AGENDA
TECHNICAL REVIEW COMMITTEE
AUGUST 7, 2018
10:00AM

WESTMINSTER PINE RIDGE ROADWAY & UTILITY DEVELOPMENT CONSTRUCTION PLANS CITY OF FRUITLAND PARK, FLORIDA

**CITY OF FRUITLAND PARK
STAFF REPORT BY LPG URBAN & REGIONAL PLANNERS, INC.**

PROJECT NO.	16-043
SCALE	H:1"=40'; V:1"= 4'
DATE	AUGUST 2017
SHEET NO.	C-10
SHEET	10 OF 18

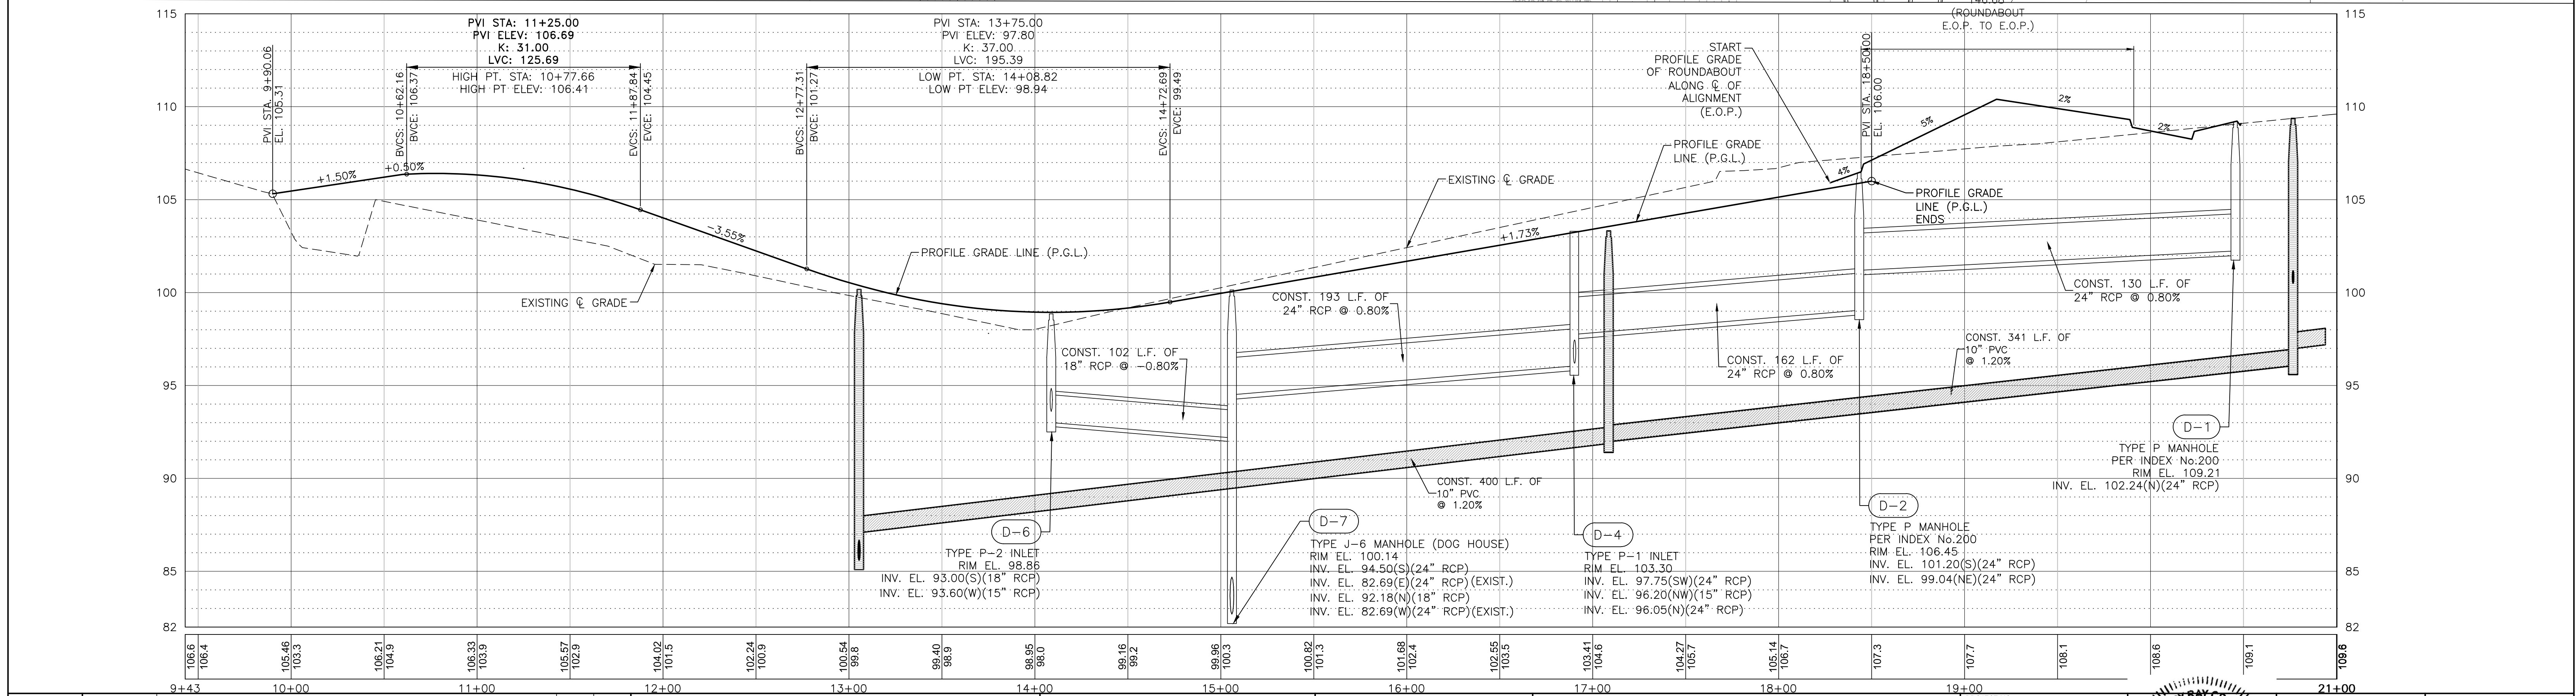
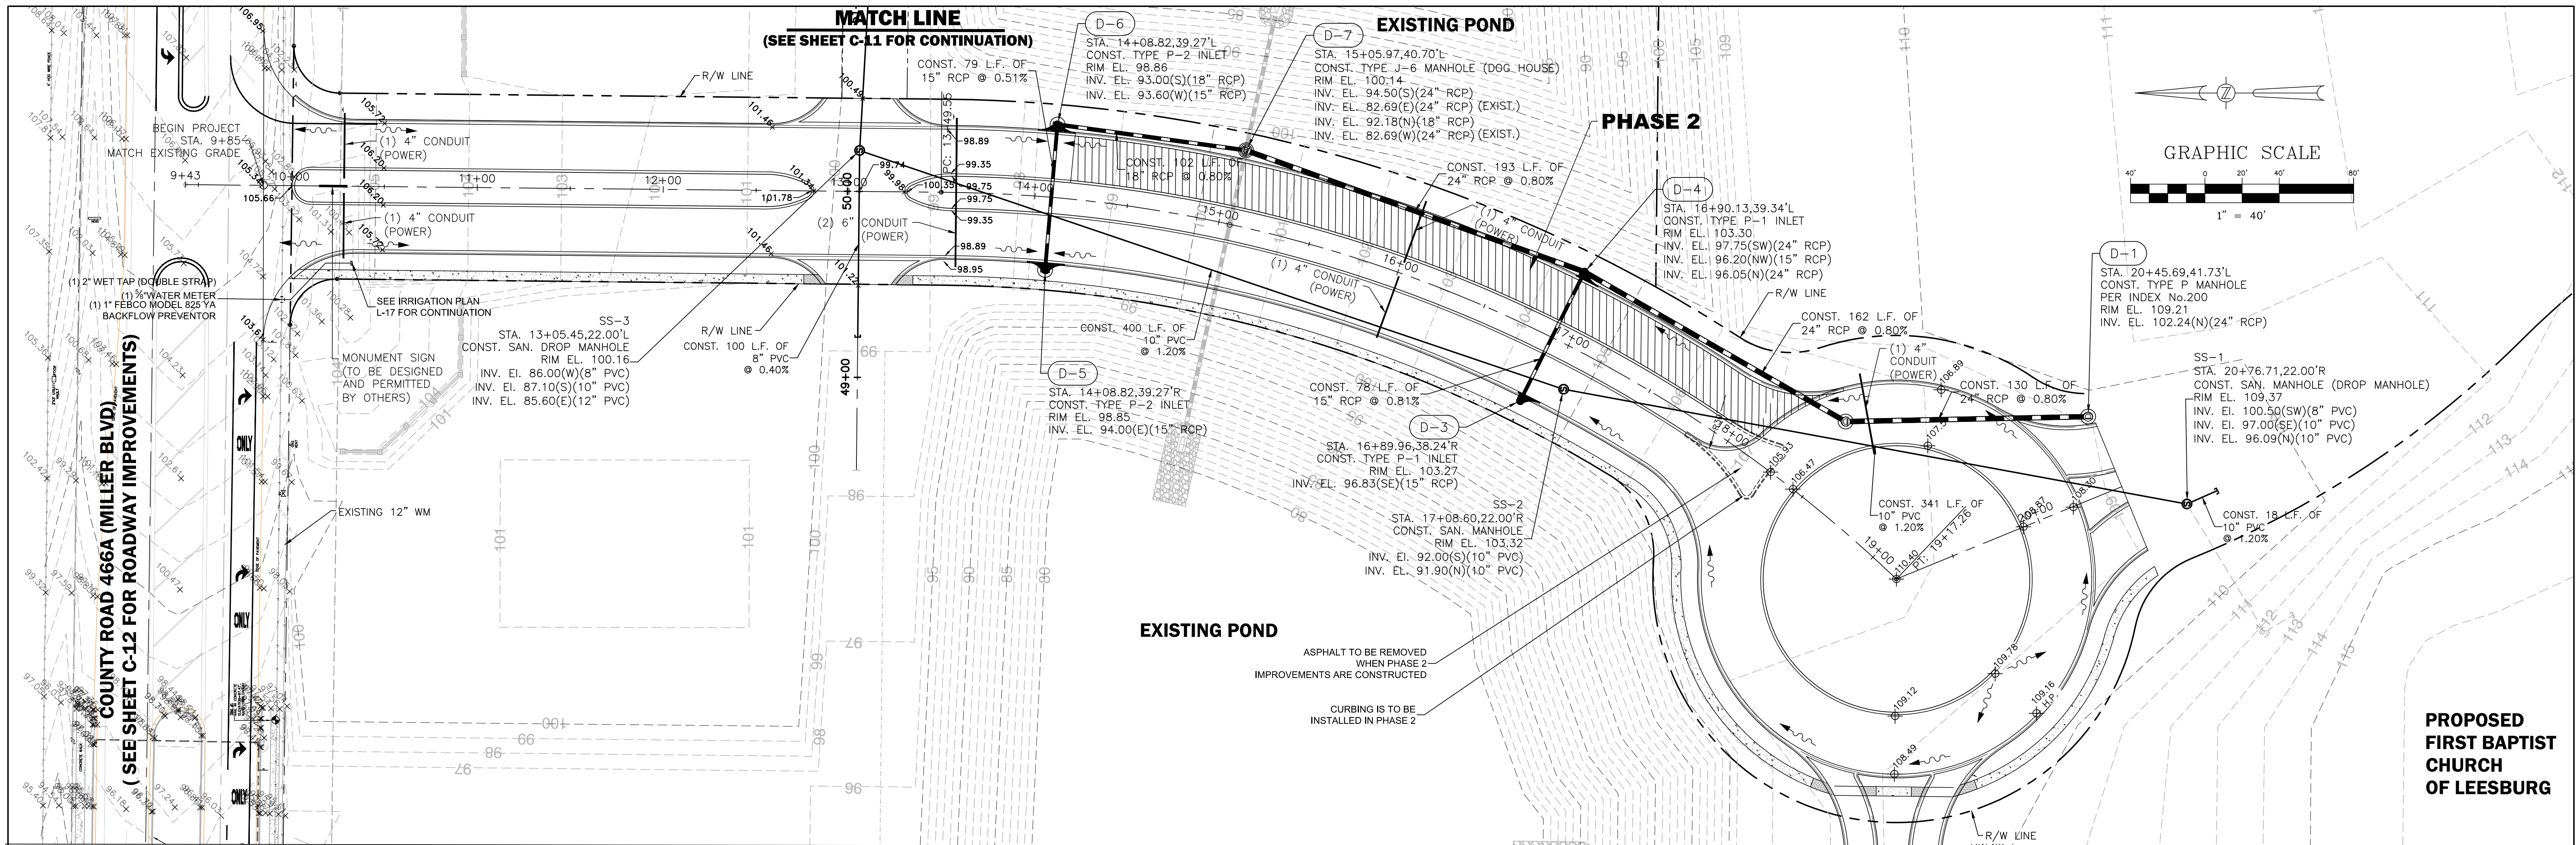
8. Sheet C-10 – Label structure D-2 in the plan view.
9. Sheet C-10 – Add additional spot grades around the roundabout and at the driveway stub outs to clarify grading.

10. Sheet C-10 – Please clarify the grading as the proposed roadway enters the roundabout. There are two separate profile grade lines that overlap, and do not meet at the same grade.

PROJECT NO.	16-043
SCALE	NOTED
DATE	AUGUST 2017
SHEET NO.	C-11
SHEET	11 OF 18

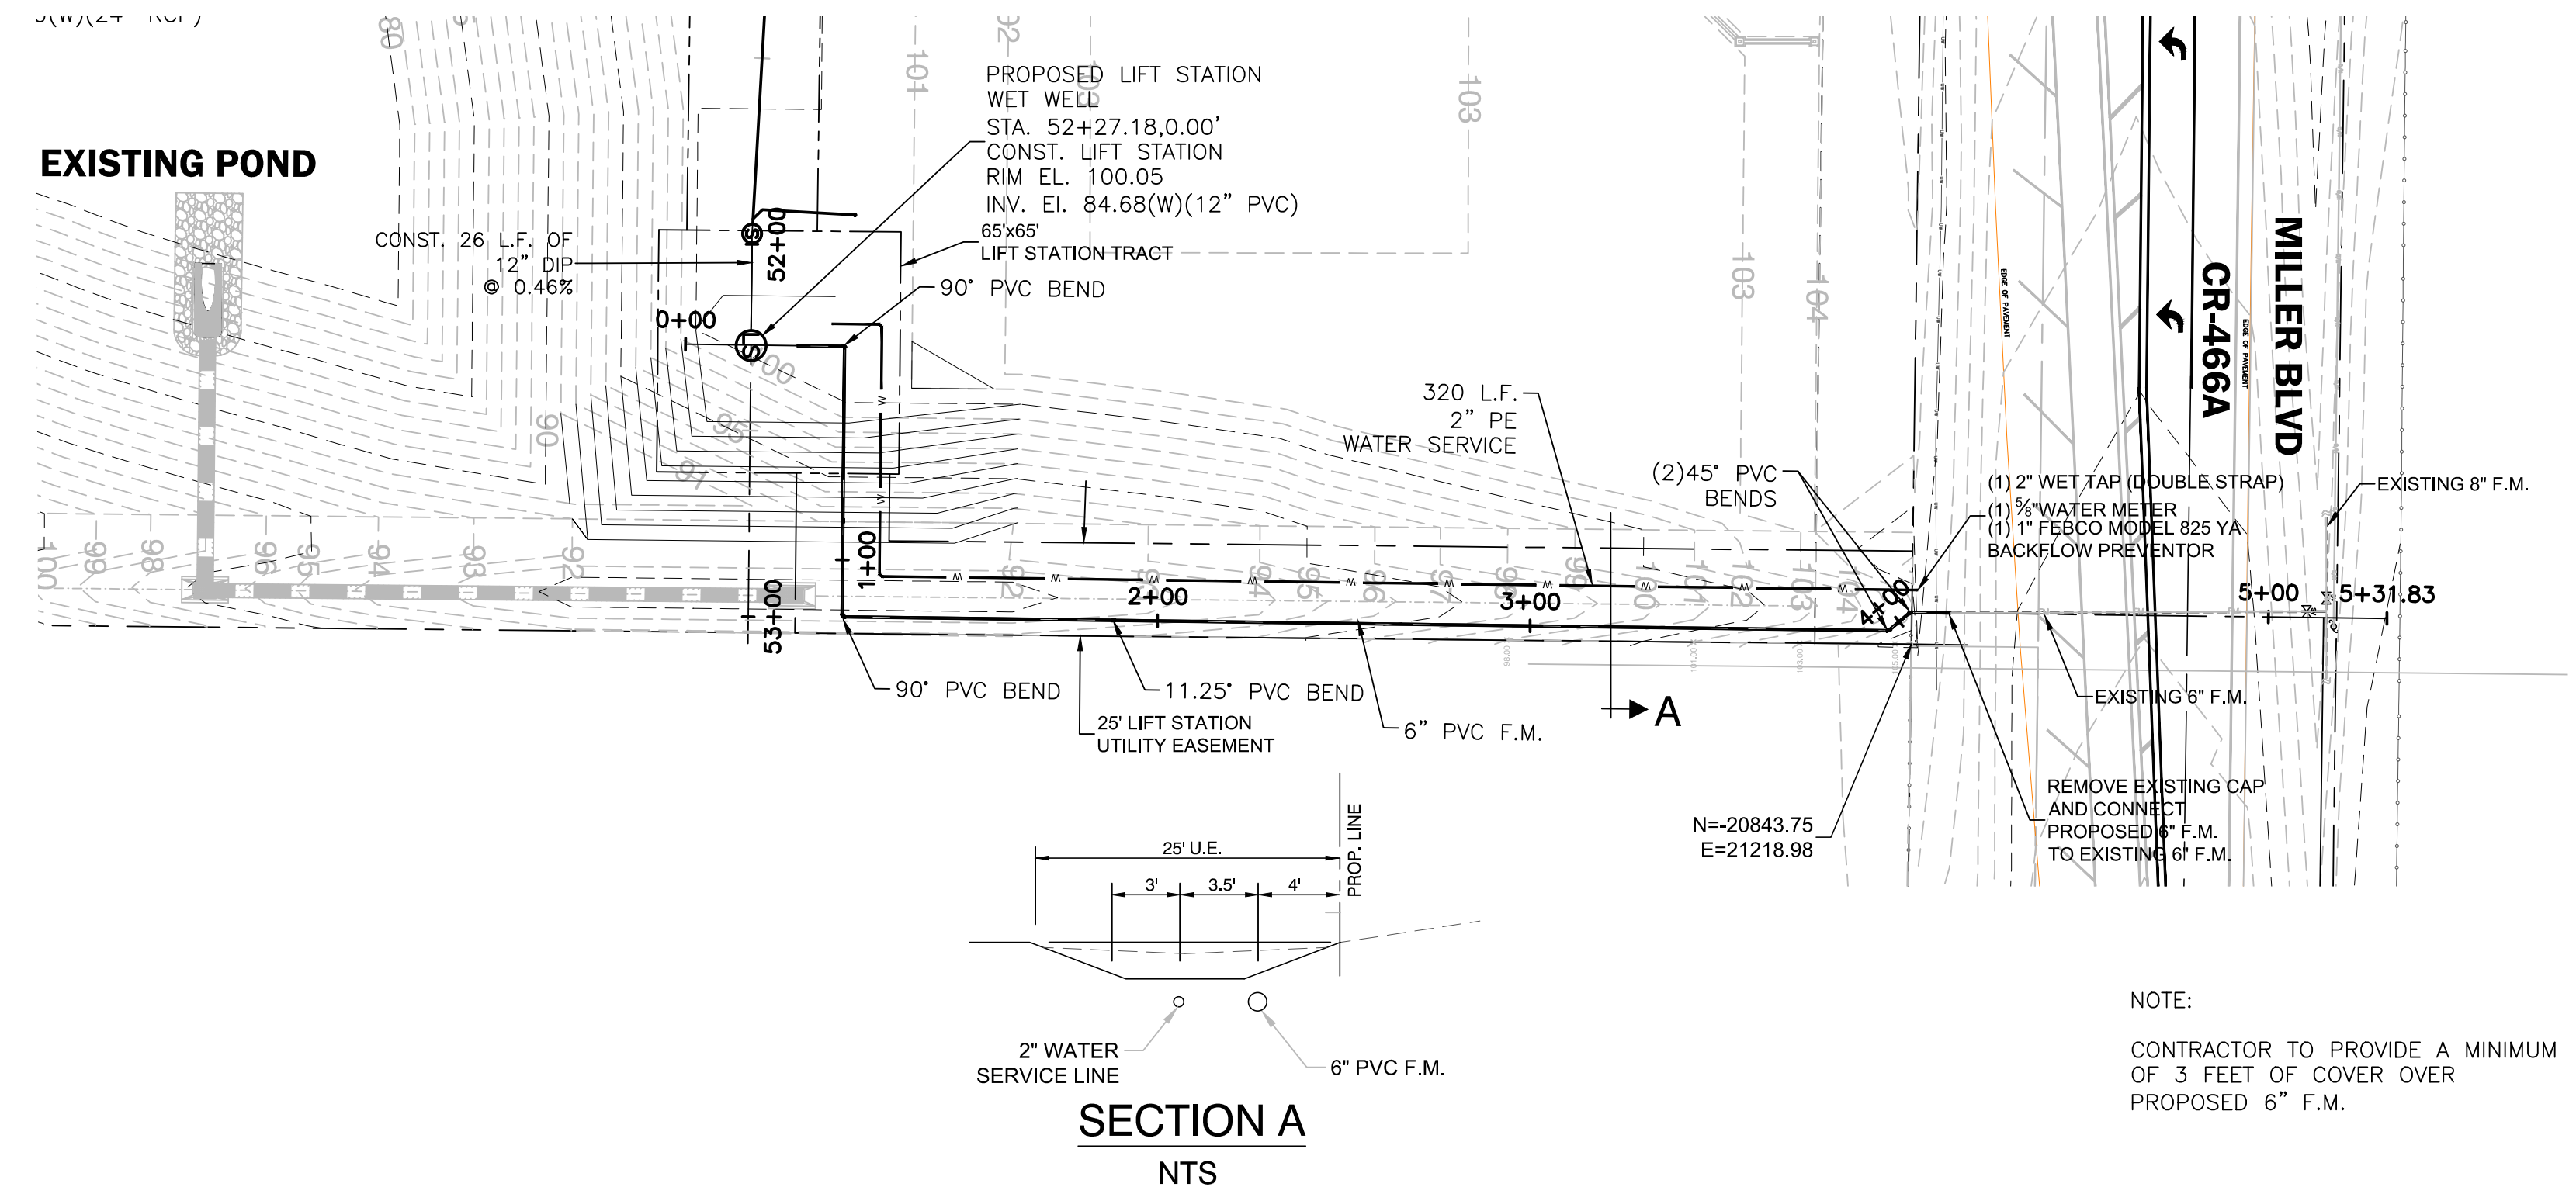
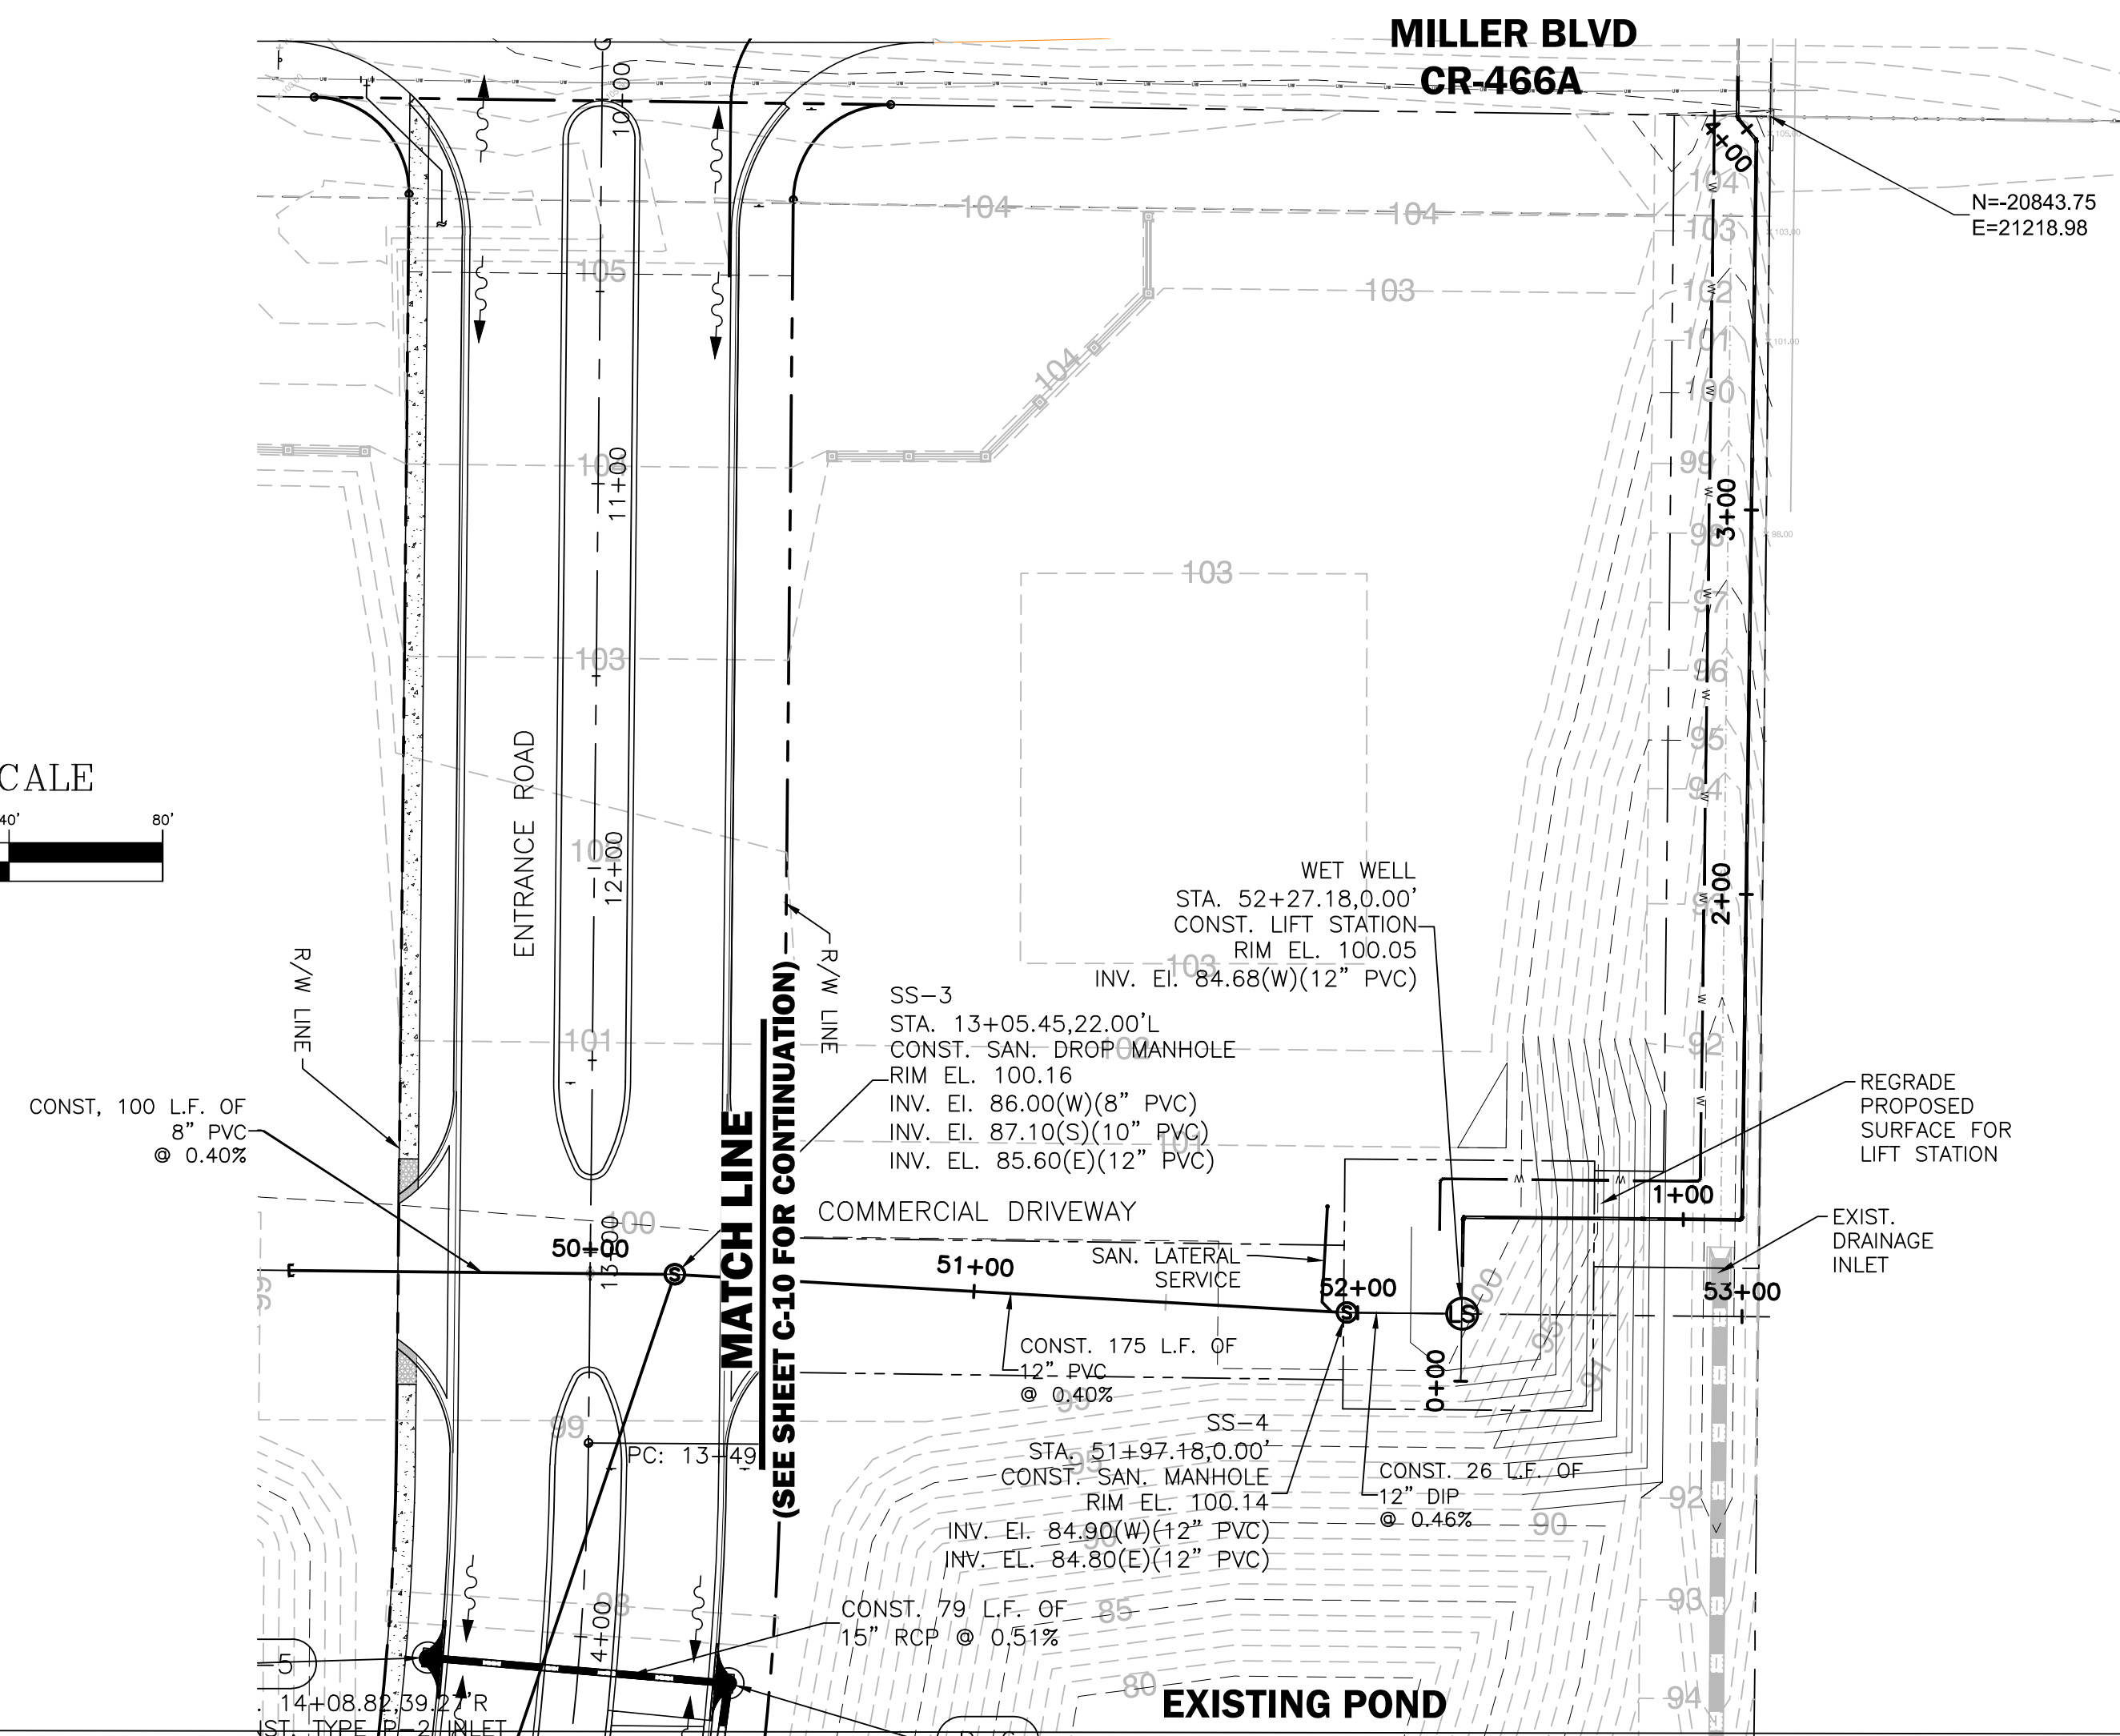
11. Sheet C-11 – Install a plug valve on the proposed force main at the right-of-way line.
